Impress Newtex Composite Textiles Ltd. (Extension)

Gorai Industrial Area, Mirzapur, Tangail
(24.089497, 90.171619)
7 November 2021

Observations: Multipurpose office Building

Column layout

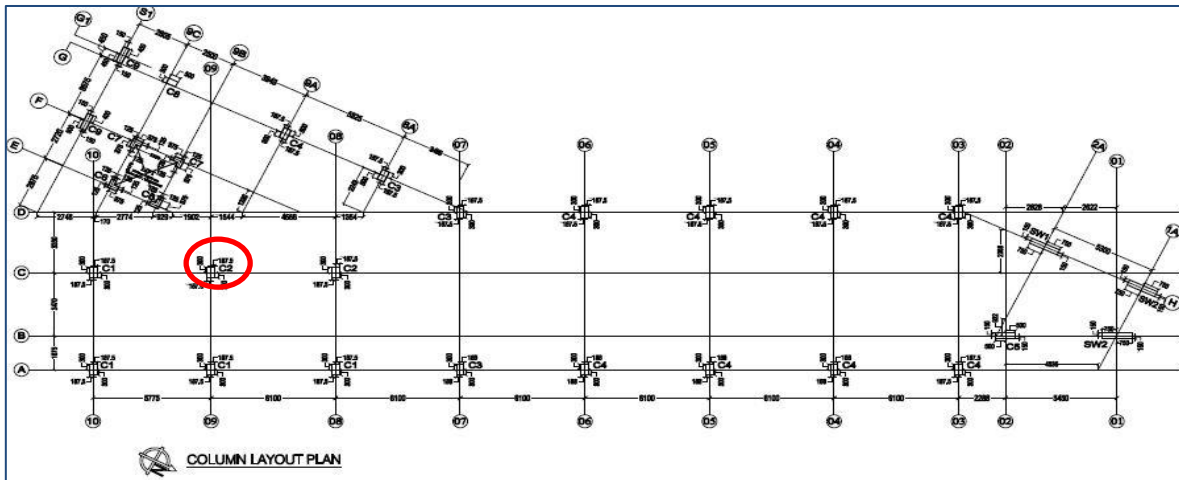
Building is irregular in shape which having one side shear wall which may occur torsional irregularity. In column capacity check there was not shown PMM ratio. No adequacy check of shear wall also found. Building engineer is required to revise design report showing all criteria.

Schedule of C2

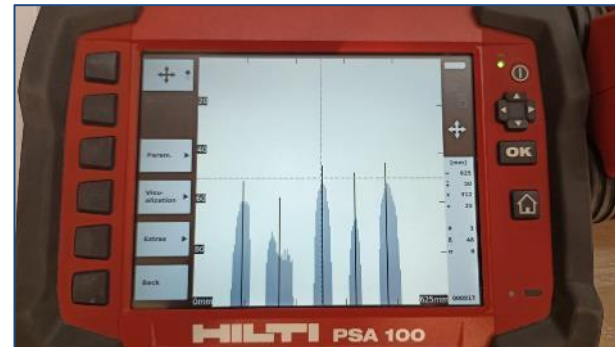
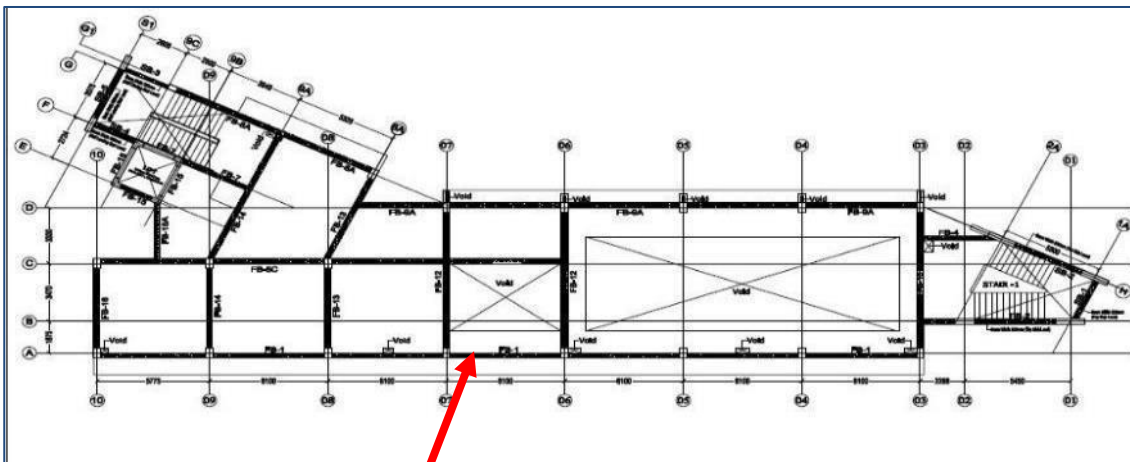
At 2nd floor to roof rebar of C2 column shown in long side is 6 in which was found 5
Building engineer is required to update the as-built drawing.

Section Of FB1

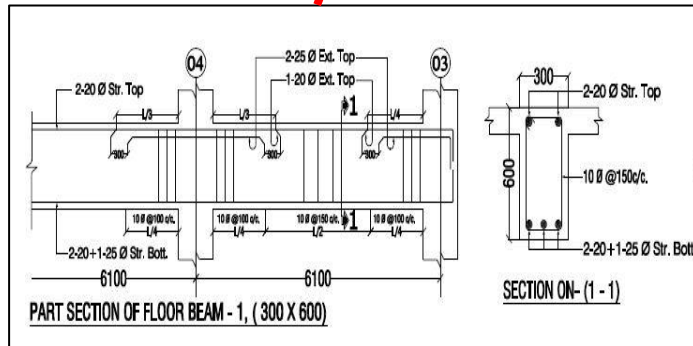
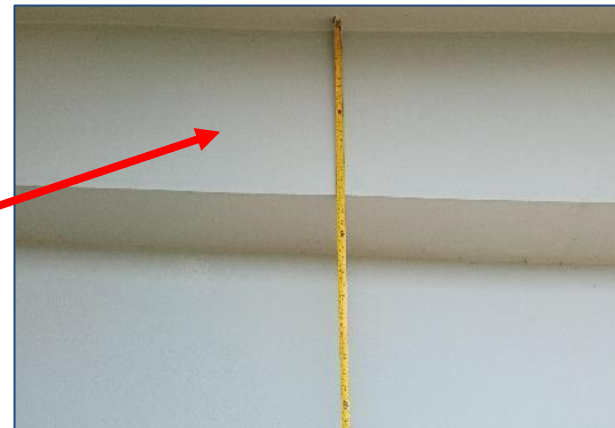
At 3rd floor roof FB1 size in drawing was 300mm X 600mm, which depth is found 675mm including slab . Building engineer is required to update the as-built drawing.

Roof Layout

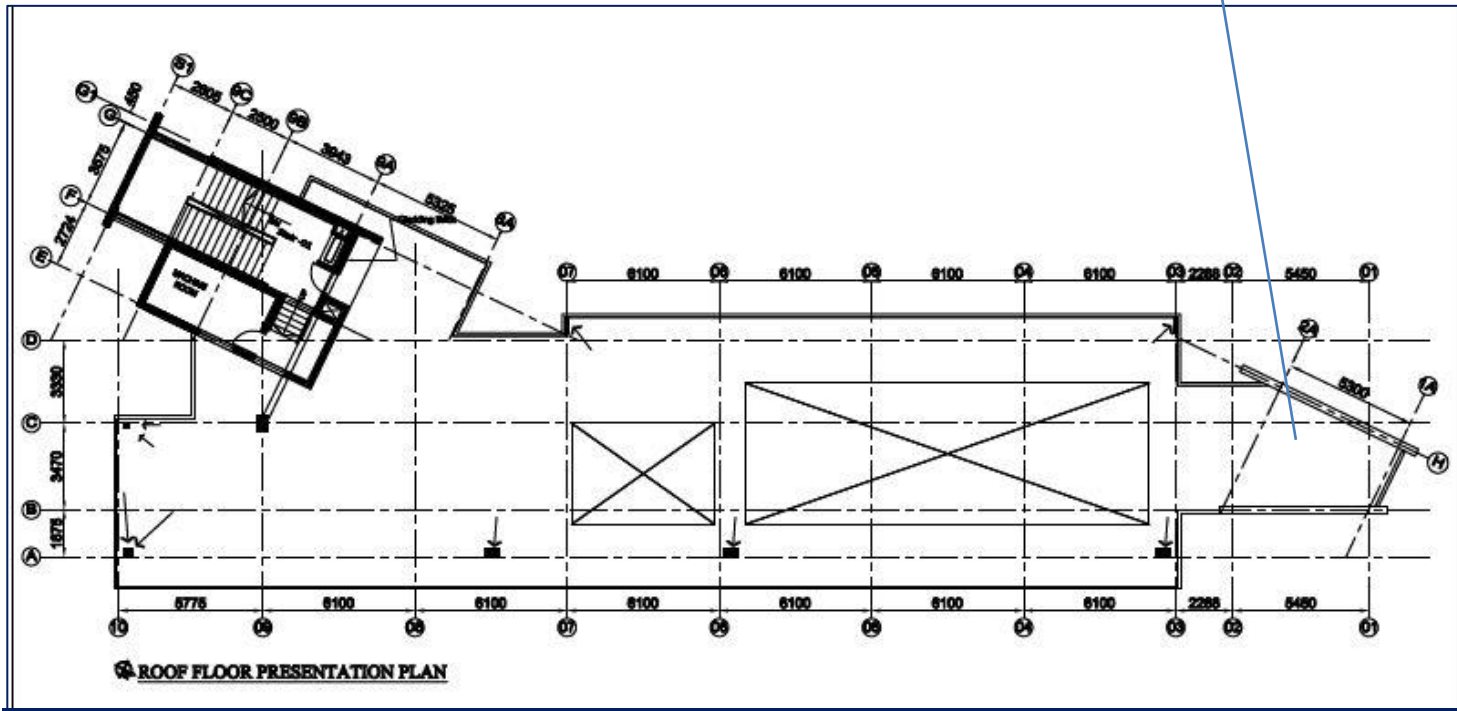
At roof there were two plastic water tank of 2000 litre capacity each which is not shown in drawing. Building engineer is required to update the as-built drawing showing those in roof layout plan.

Deflection check of 3.2 m cantilever beam and slab

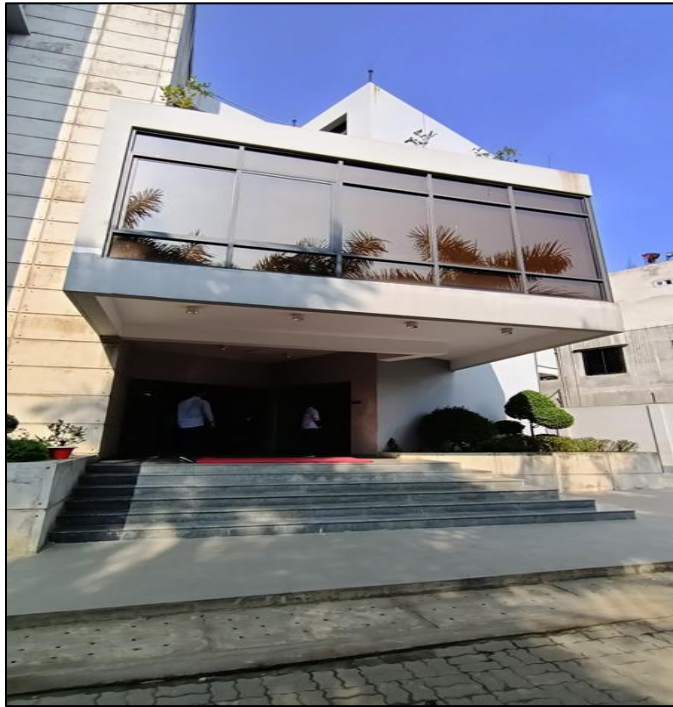
At first floor 3.2 m cantilever slab is observed. The building engineer is required to check adequacy & deflection of the cantilever slab and beam.

Lack of documents & discrepancy in as-built drawing

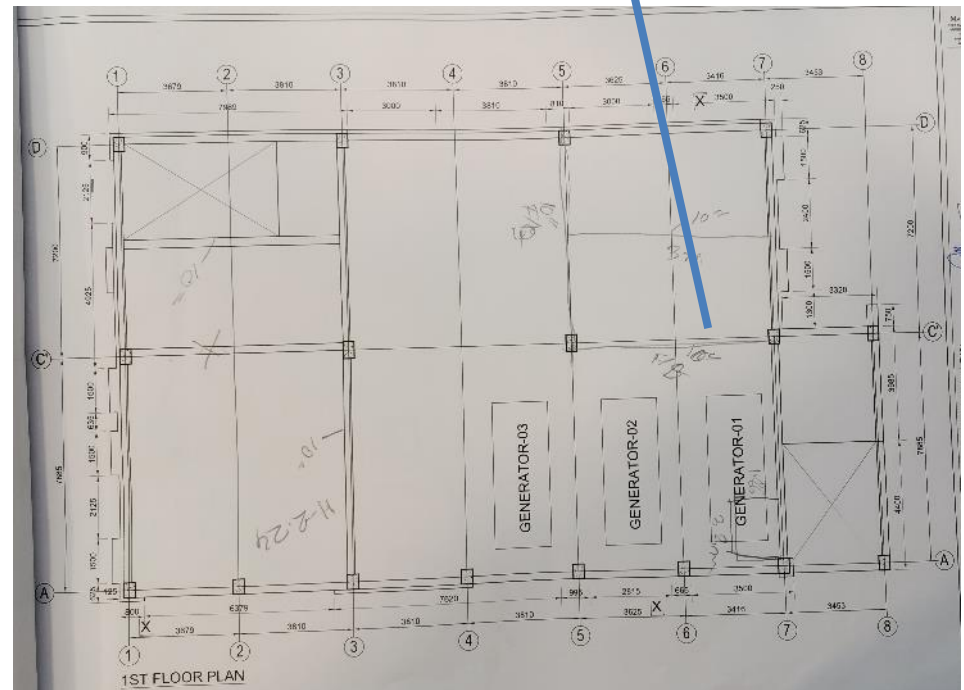
Toilet Built up at 2nd floor stair and 250mm brick wall at first floor were found on site which are not mentioned in provided as-built drawing. Building engineer is required to update the as-built drawing.

Lack of lateral stability

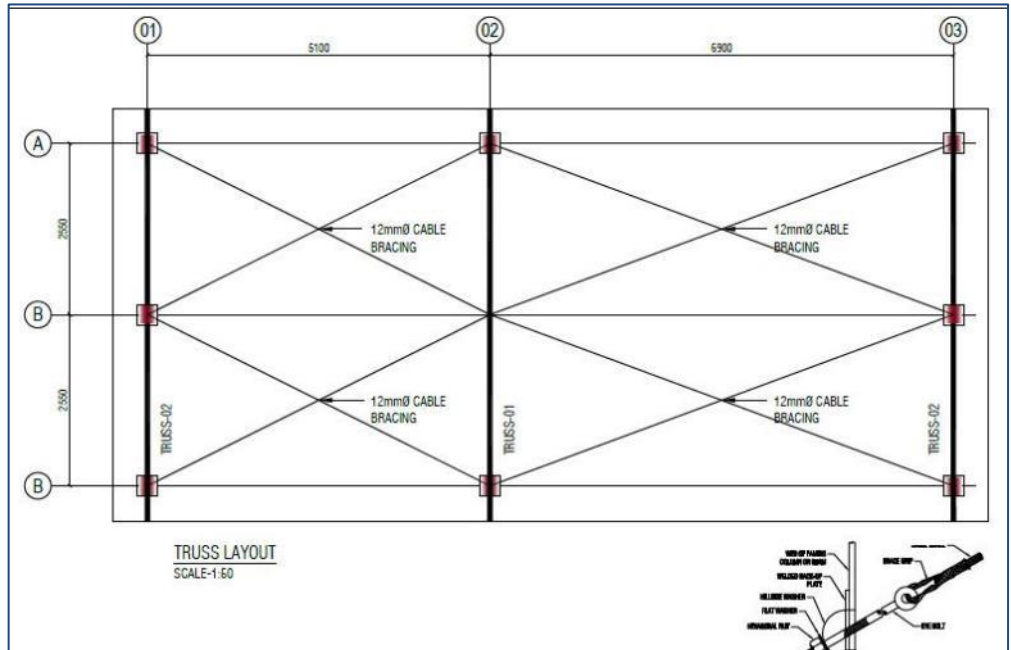
No bracings were found in as-built condition. Apparently non-engineered connection were found. Building engineer is required to check the lateral stability and connection adequacy of the structure for uplift forces.

Inconsistencies in as-built drawing

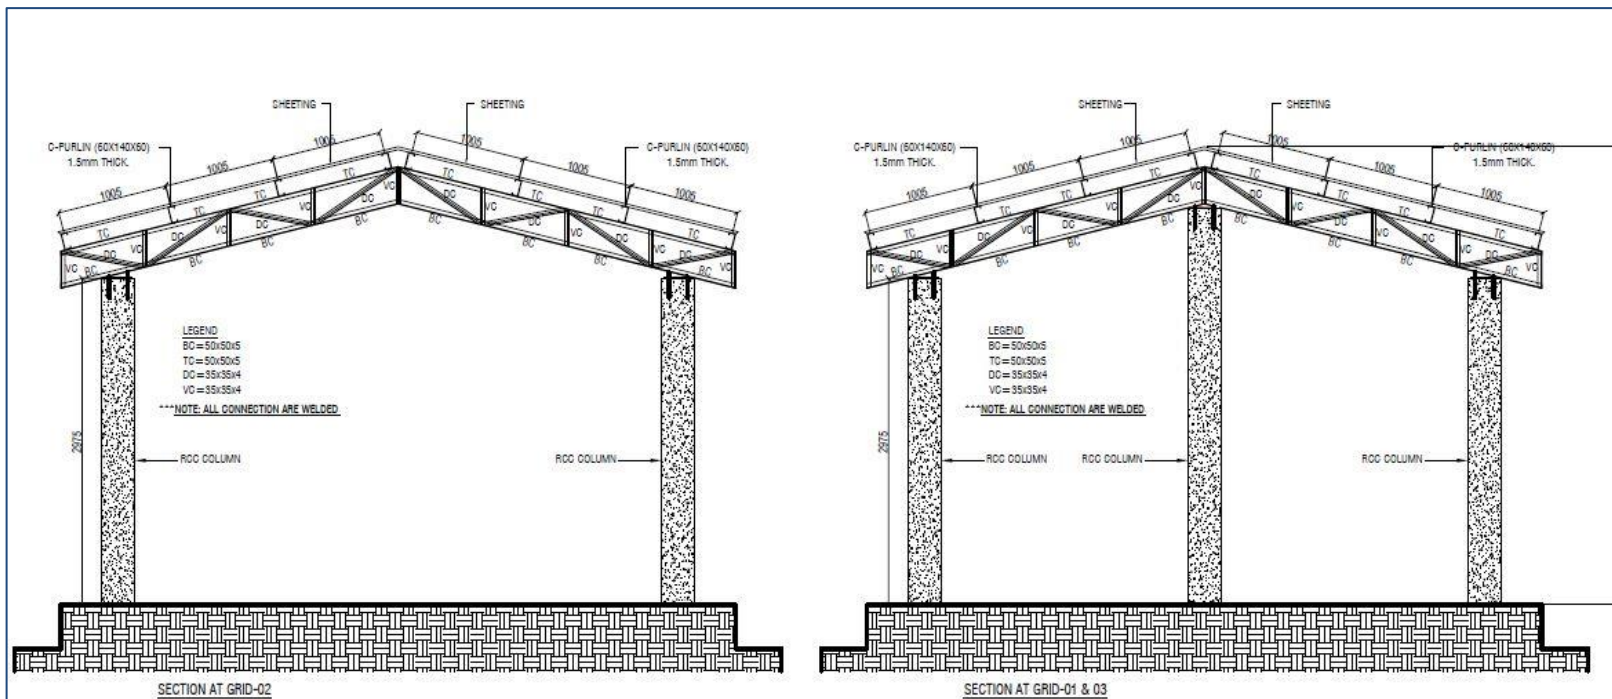
Truss sections and sizes are not matched with provided as-built drawings.

Building engineer is required to survey the whole structure and prepare as-constructed drawing.
